UNITED STATES PATENT AND TRADEMARK OFFICE

APPLICATION NO.	FILING DATE	FIRST NAMED INVENTOR	ATTORNEY DOCKET NO.	CONFIRMATION NO.
10/536,545	11/07/2005	Larry Salvadori	20518/51 (S-8500)	9818
<div>7590 09/28/2007</div> <div>Tyco Heathcare Gap LP IP Legal Dept. 15 Hampshire st. Mansfield, MA 02048</div> <div>EXAMINER CAMPBELL, VICTORIA P</div> <div>ART UNIT PAPER NUMBER</div> <div>3709</div> <div>MAIL DATE DELIVERY MODE</div> <div>09/28/2007 PAPER</div>

Office Action Summary

DETAILED ACTION

9. Claims 1-4, 6, 7, 9, and 11-14 are rejected under 35 U.S.C. 102(b) as being anticipated by US Design Patent No. 264,246 to Ekbladh et al. Regarding the abovementioned claims, Ekbladh et al teach the following (see attached drawing distinctly pointing out claimed features on Figure 1 of D264,246):

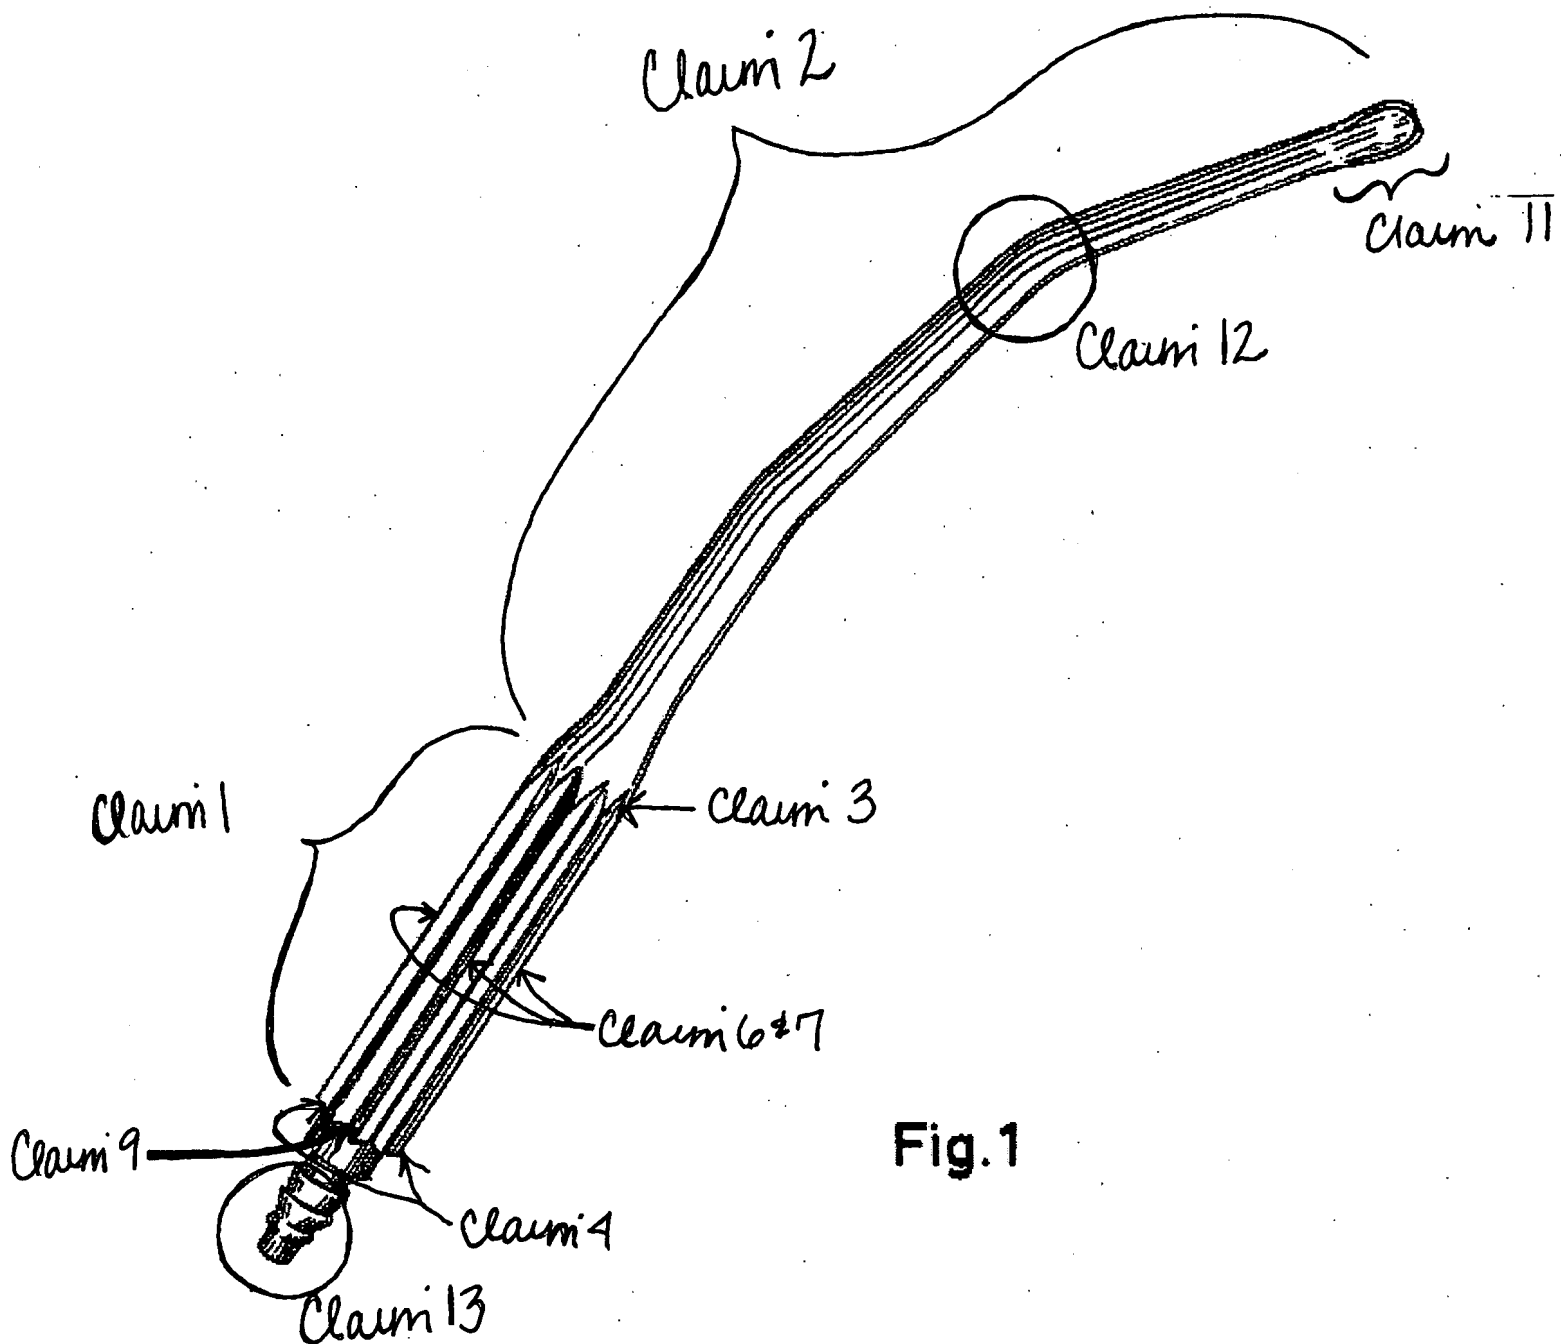
Regarding claim 14, the surgical tool depicted has a handle shorter than its elongated extension. Both portions have similar diameters, therefore the mass of the elongated extension will pull the center of mass distal of the handle.
